APPEAL SUMMARY

Appeal ID: 27740	Project Address: 3637 NE 43rd Ave
Hearing Date: 5/11/22	Appellant Name: Zoe Bailey
Case No.: B-006	Appellant Phone: 503-314-3455
Appeal Type: Building	Plans Examiner/Inspector: Mike Rider
Project Type: residential	Stories: 2 Occupancy: Residential Construction Type: Light frame wood construction
Building/Business Name:	Fire Sprinklers: No
Appeal Involves: Reconsideration of appeal	LUR or Permit Application No.:
Plan Submitted Option: pdf [File 1] [File 2]	Proposed use: ADU

Code Section 2010 OSISC 304.9.1 General Pathway Requirements

1. ENLARGED ROOF PLAN (ROOF AND MODULES SHOWN SKEWED)

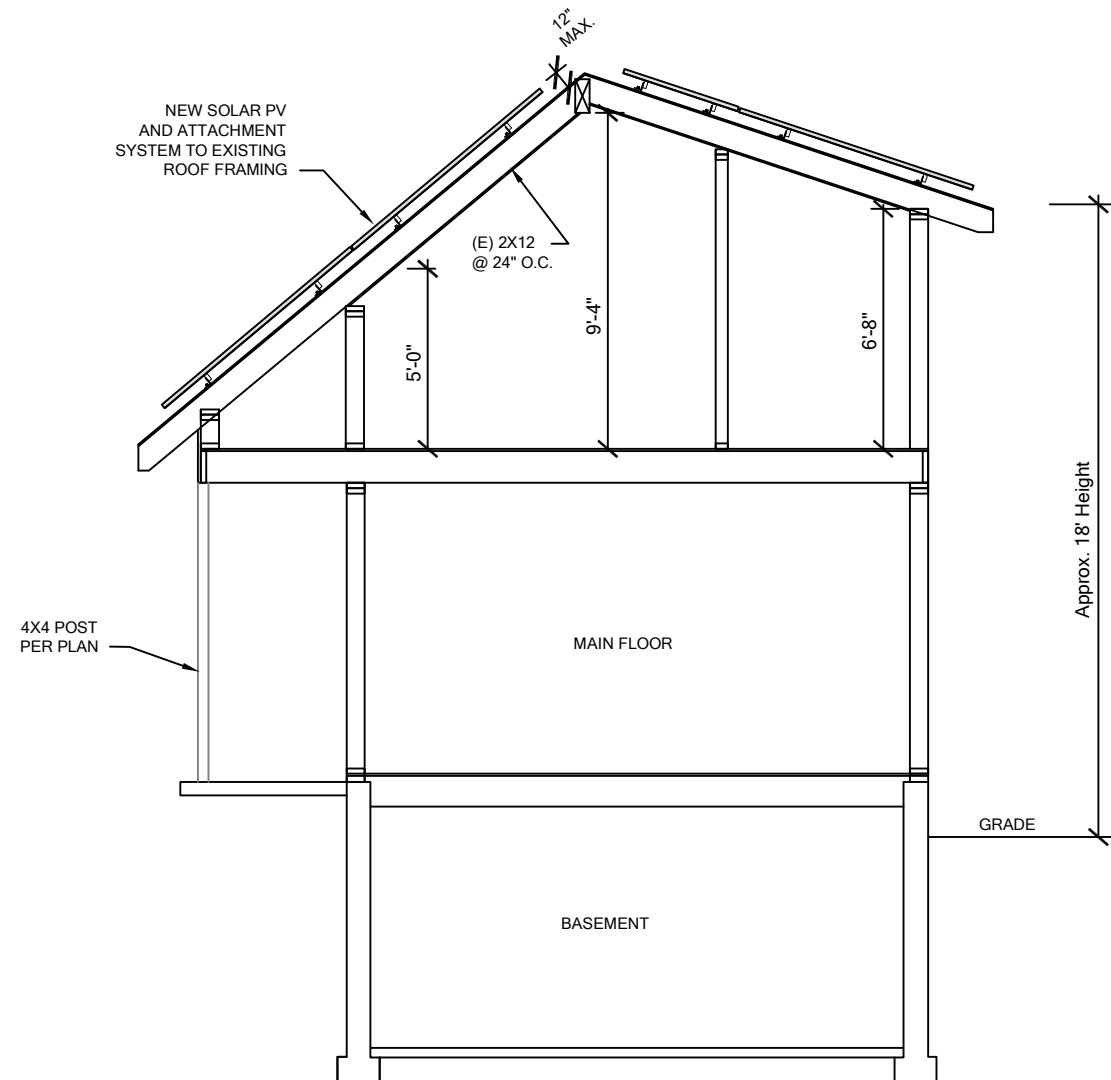
We would like to provide a 36" FF pathway on the North and South edges of the roof and a 24" and 12" FF pathway along the East and Westing facing roof ridge. (See pathways on page D.03 of attachment)

We would like to provide a 36" FF pathway on the North and South edges of the roof and a 24" FF pathway along the East and Westing facing roof ridge. (See pathways on page D.03 of attachment)

Original Text: Due to the small nature of this ADU(18'x16' footprint), the lack of attic space, and skylight on the East facing roof next to our 36" FF pathway. Would having a 36" pathway along 2 sides instead of 3 provide enough space for ventilation purposes, firefighter movement and or placement to hook a rood ladder?

We can put a 24" pathway along the East and West facing roof ridge

Modules on East array have been shifted toward the eave to provide larger pathway at roof ridge

Provide a 36 inch pathway on two sides of solar array and a 24 inch minimum pathway along the roof ridge: Granted provided the final plan set clearly shows:

36" firefighter pathways along the north side of the roof

36" firefighter pathways along the south side of the roof

24" firefighter pathway along the west side of the ridge

24" firefighter pathway along the east side of the ridge
